ADDENDUM NO. 1

**HANOVER COMMUNITY SCHOOL CORPORATION - NEW RESOURCE
CENTER AND RELATED WORK
Cedar Lake, IN 46303**

This Addendum consists of page ADD 1-1 and attached Addendum No. 1 from Gibraltar Design dated May 27, 2021 and consisting of 5 pages and 48 drawings.

Z:\cad\projects\2020 - 2028\2021 Projects\2104 Gibraltar Design Hanover\A-502 ENLARGED PLAN DETAILS.dwg, 5/27/2021 1:41:05 PM, jflitzgerald

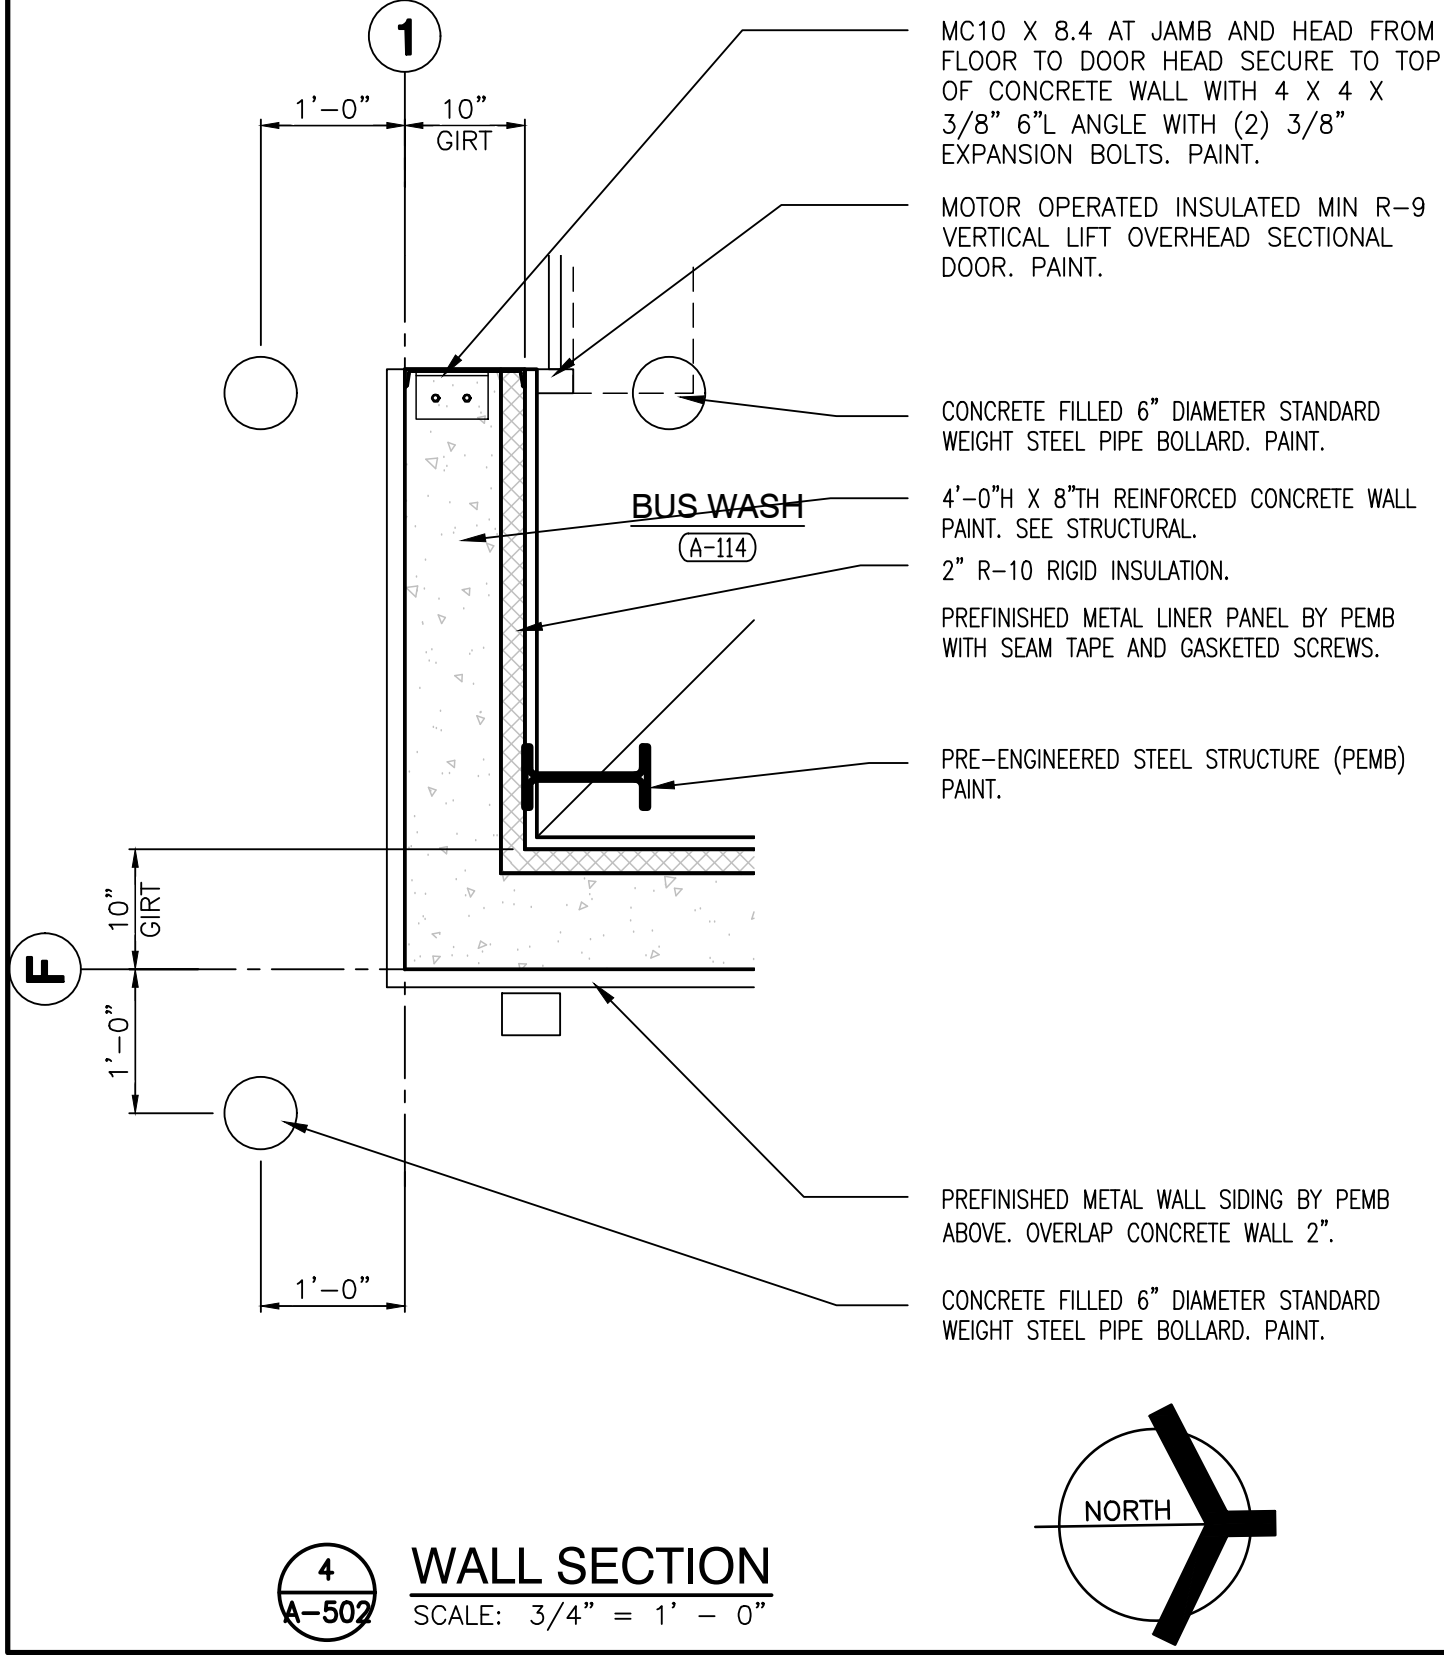
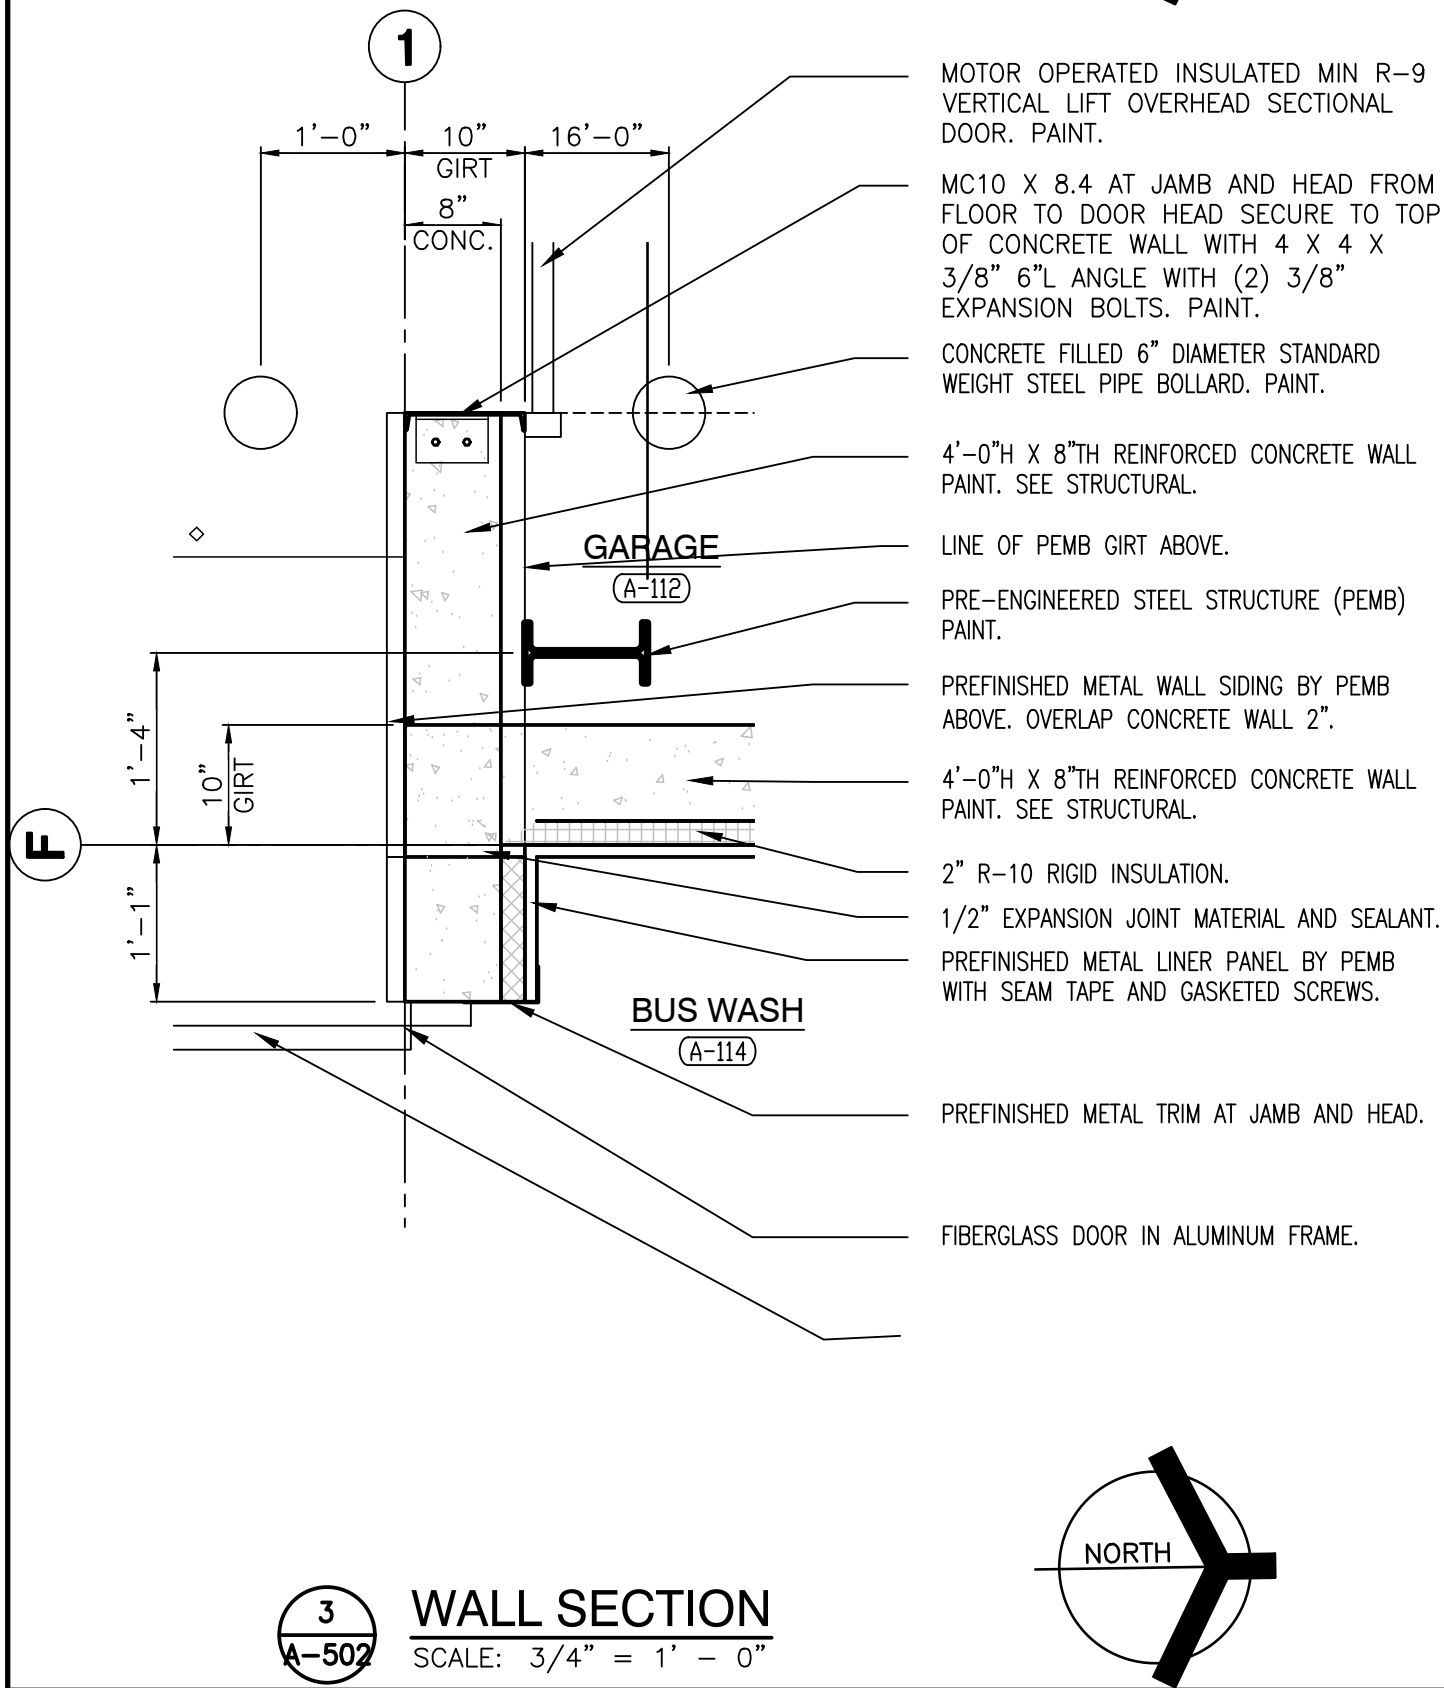
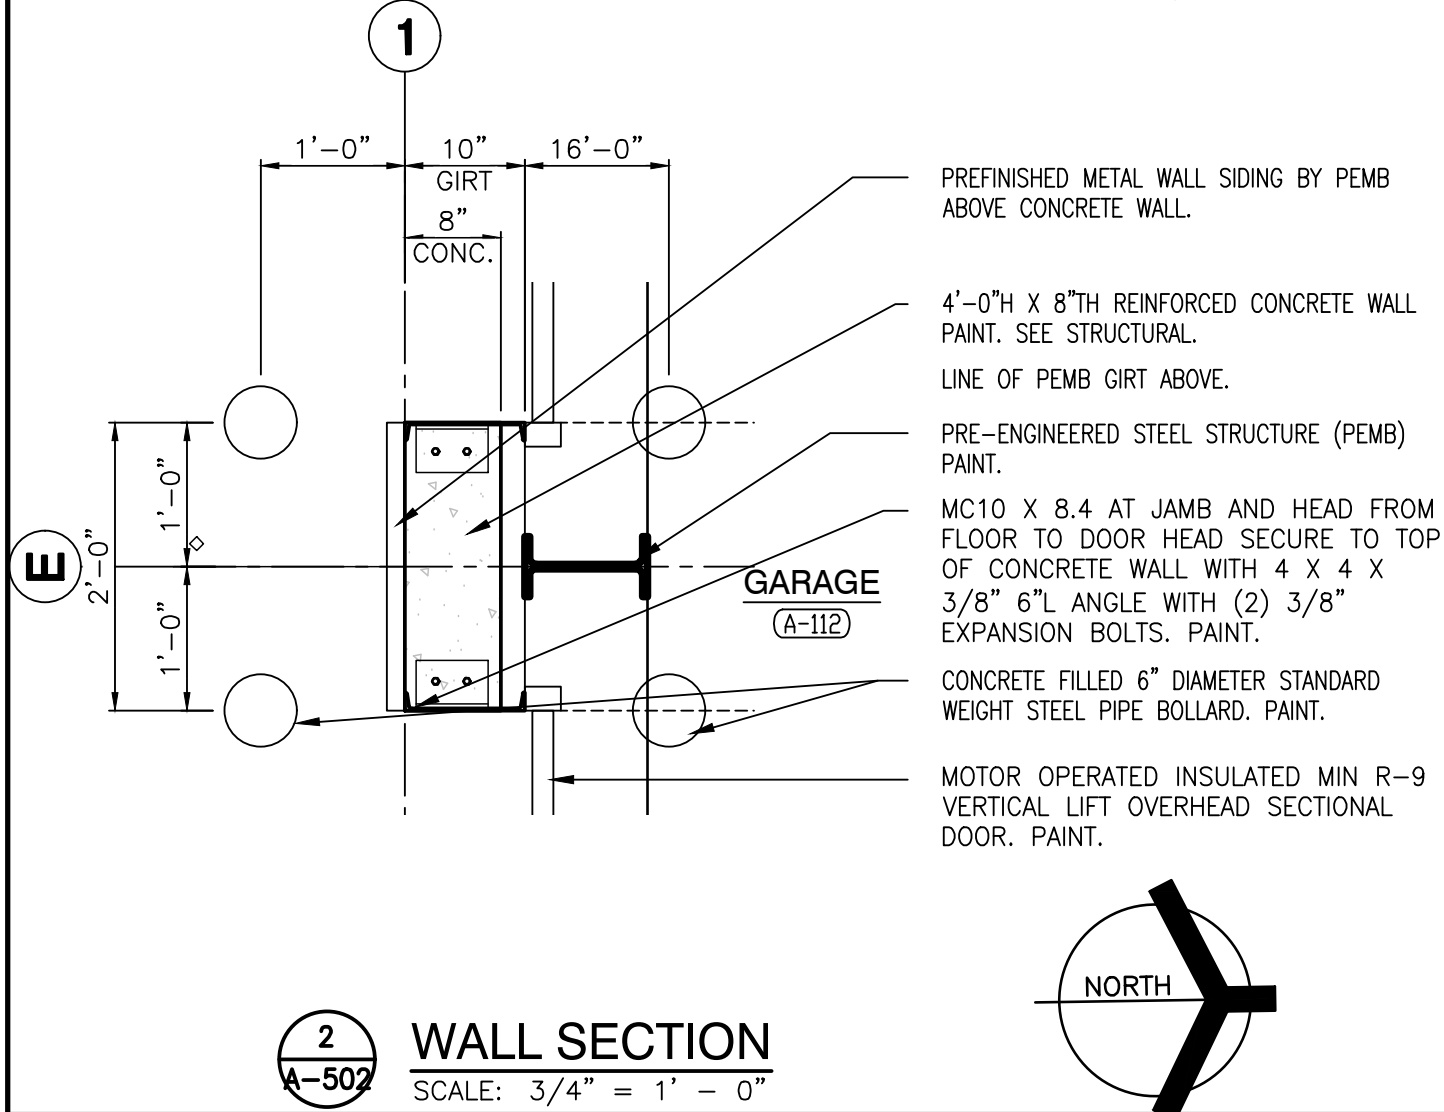
17. Sheet A-502

- A. Refer to Full Size Drawing Sheet included in this Addendum for the following revisions:
 - 1. Delete Baby Changing Table from MEN D-128 and WOMEN D-129.

FIRST FLOOR REFLECTED CEILING PLAN - BUILDING D
SCALE: 1/8" = 1'-0"

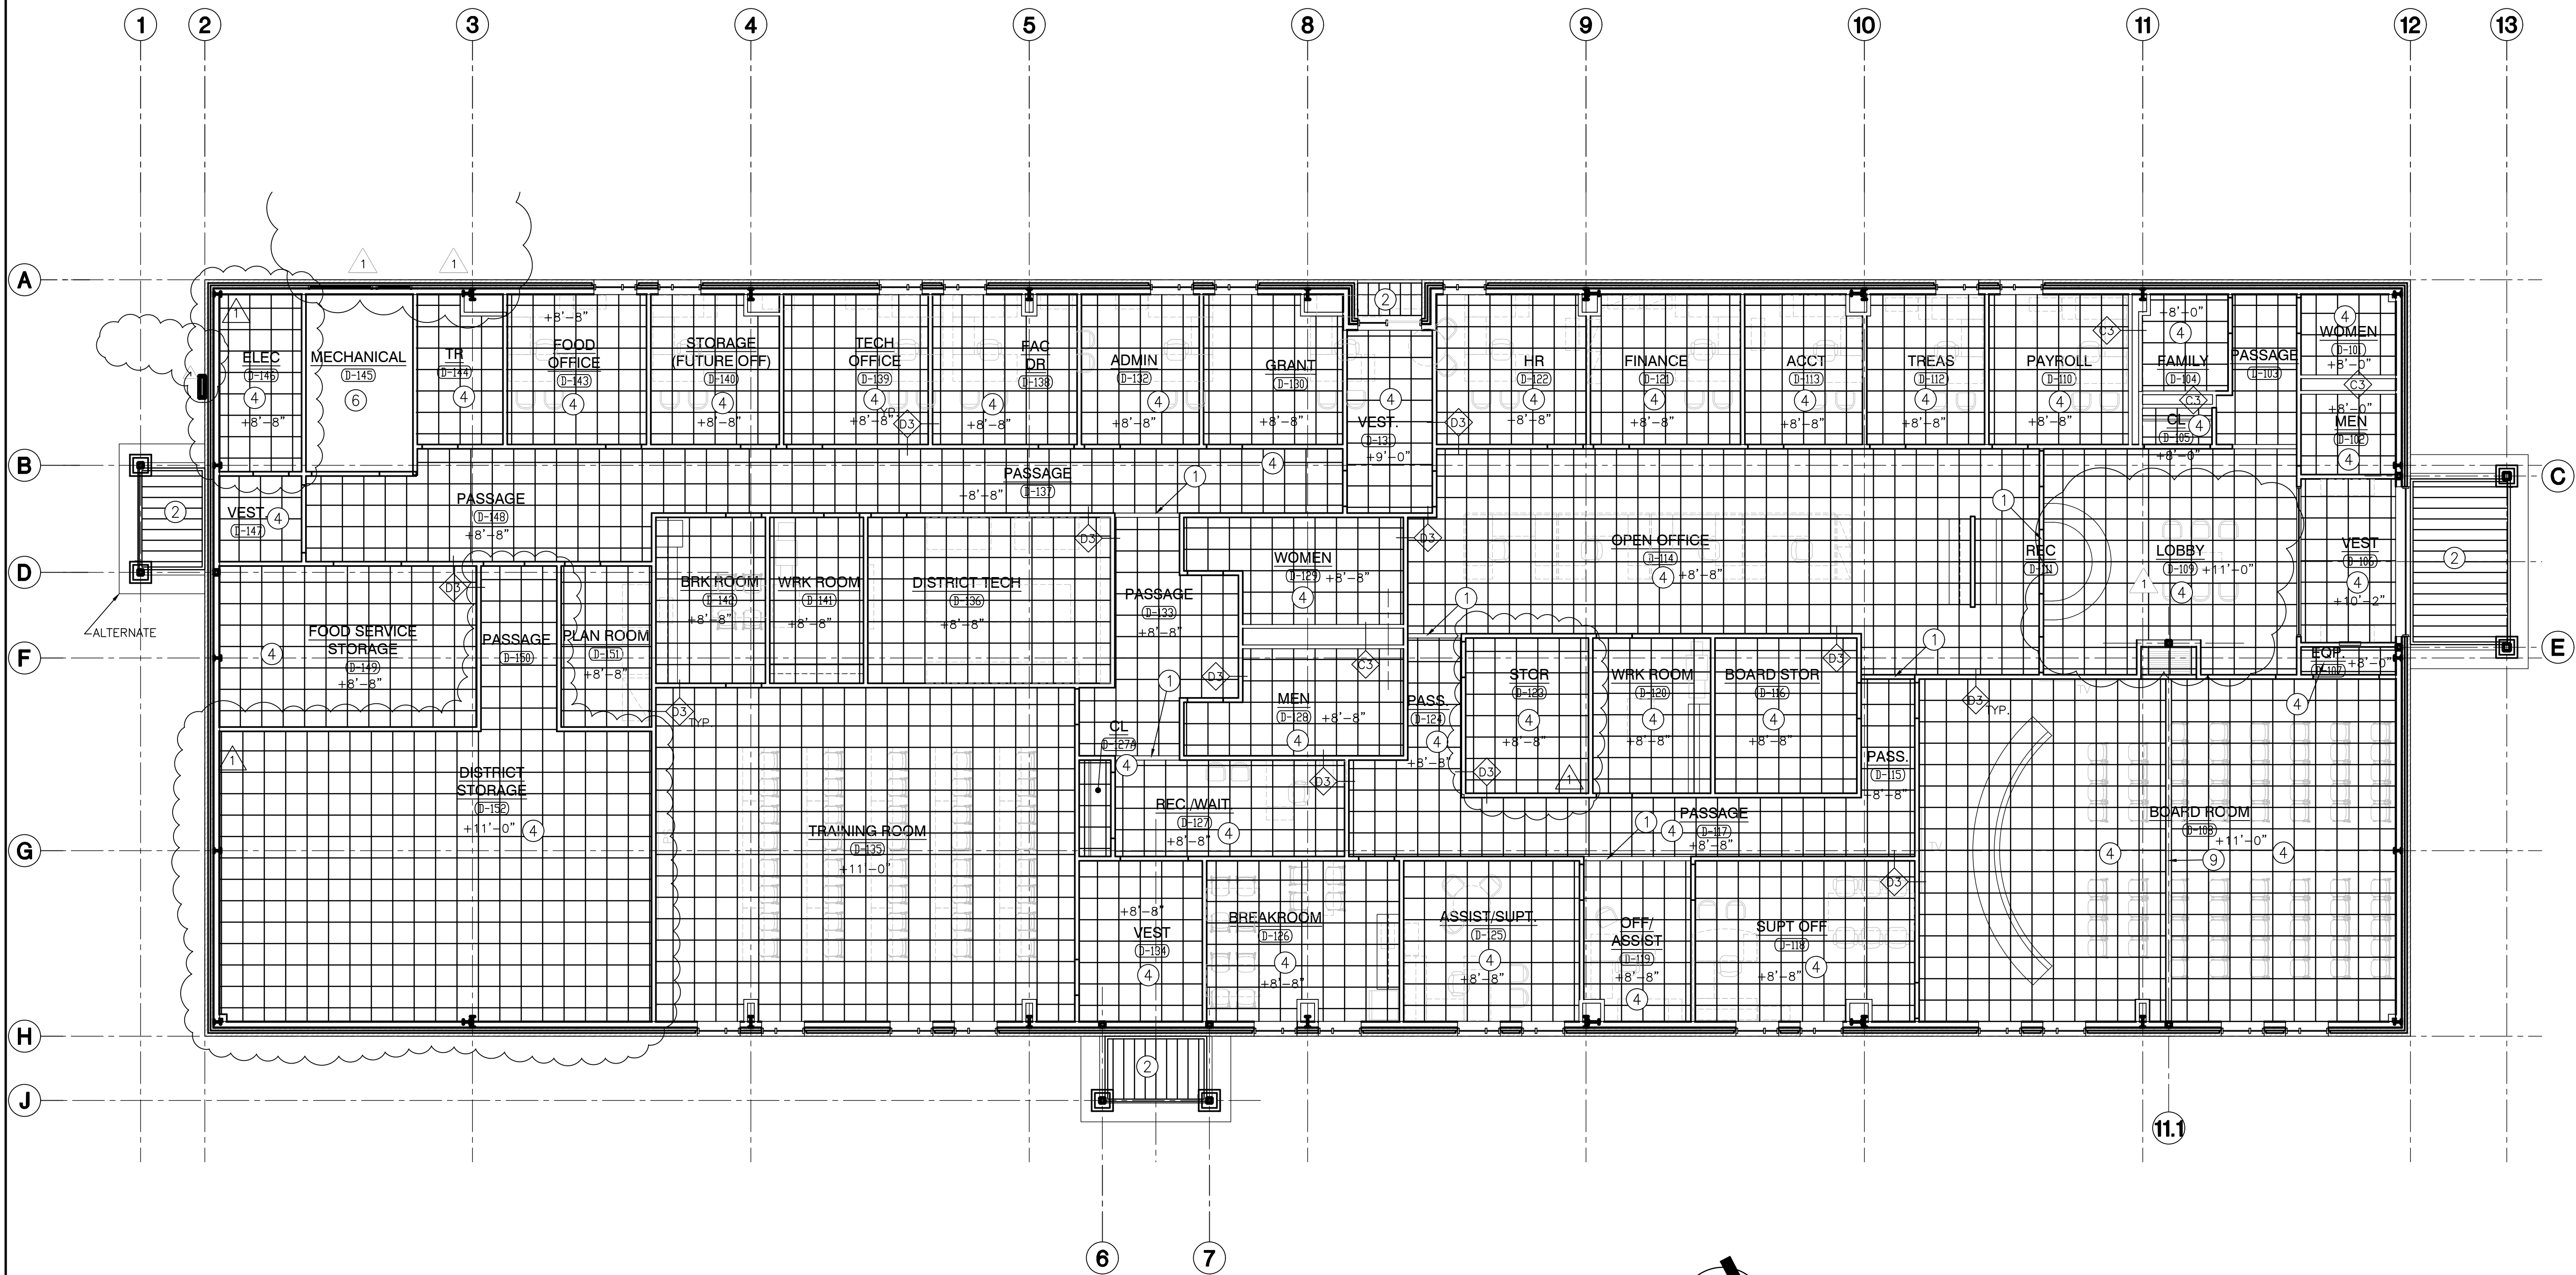
22. Sheet A-904

- A. Refer to revised full size drawing included in this Addendum for the following revisions:
 - 1. Add suspended acoustical tile ceiling ACT-1 to Rooms: LOBBY D-109, STOR D-123, ELEC D-146, PASSAGE D-150 and DISTRICT STORAGE D-152.
